RE: Comments on Proposed Rule Revisions - Iowa Administrative Code (IAC) 567-Chapter 113
"MSW Landfills"

This letter provides Liesch Associates, Inc. (Liesch) comments on the proposed changes to the Iowa Department of Natural Resources (IDNR) rules regarding leachate collection system design and construction, and the requirement that sealed double-ring infiltrometers be used as the final quality control test for clay barrier layers.

SECTION: LEACHATE COLLECTION LATERAL TRENCH

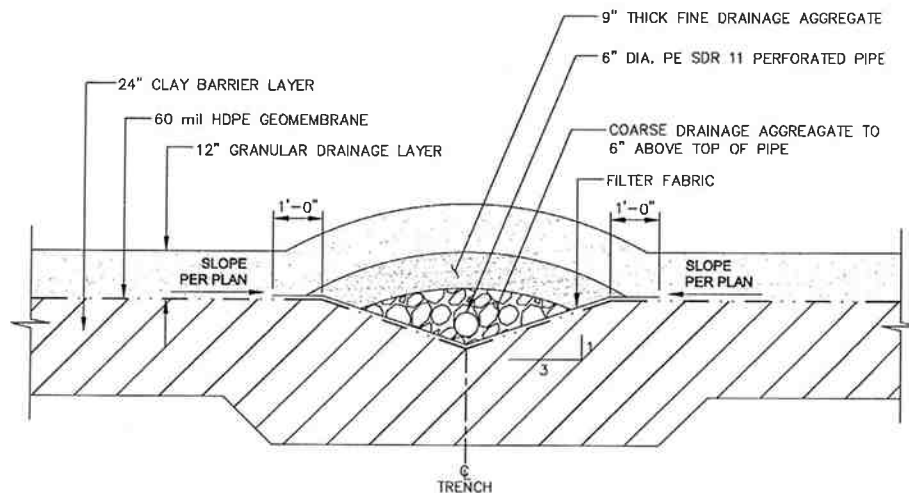
With respect to the four-part leachate collection system described in the proposed rule, the language may just need some clarification. If the intent of this part of the rule is to require facilities to provide a graded filter around leachate collection piping, our issue is only with the requirement that a geotextile separator be placed between the drainage material types as

it is widely recognized that there is a potential for biofouling of geotextiles in leachate collection systems. We have been designing and building landfills for several years using graded filters composed entirely of layers of compatible granular materials that have eliminated the need for a geotextile filter between adjacent layers with no reduction in performance. A typical detail of the graded filter is provided below. Again, if the intent of this part of the rule is to require graded filters around leachate collection piping, we suggest that the language of the rule be revised to reflect a performance-based approach requiring simply that the design consider and prevent migration of fines into the piping system.

If, instead, it is the intent of the IDNR to require the multi-layer drainage system (6-inches of high hydraulic conductivity material overlain by geotextile separator and 6-inches of coarse granular material) be constructed over the entire landfill liner system, we believe this requirement is unnecessary, costly, and problematic from both functional and construction perspectives. Functionally, leachate transport in granular and geocomposite layers is well-understood and the drainage required to limit head on the liner to less than 30 cm (12-inches) can be readily achieved using a simple monolayer of appropriately-designed granular material or geocomposite, assuming appropriate factors of safety and reduction factors for the leachate characteristics and practices utilized at the facility (e.g. leachate recirculation).

With respect to constructibility, placement of a minimum thickness of 6-inches of each layer of drainage material (high hydraulic conductivity and coarse) is feasible and appropriate around the leachate collection piping components of a liner system, but not over the entire primary liner system. Even with a geotextile cushion, Liesch would not endorse placement of granular drainage materials of any type over flexible membrane base liners at a thickness of less than 12-inches, even with the use of low ground pressure (LGP<5 psi) construction equipment.. In high traffic areas, e.g. haul roads, we would not recommend a thickness of
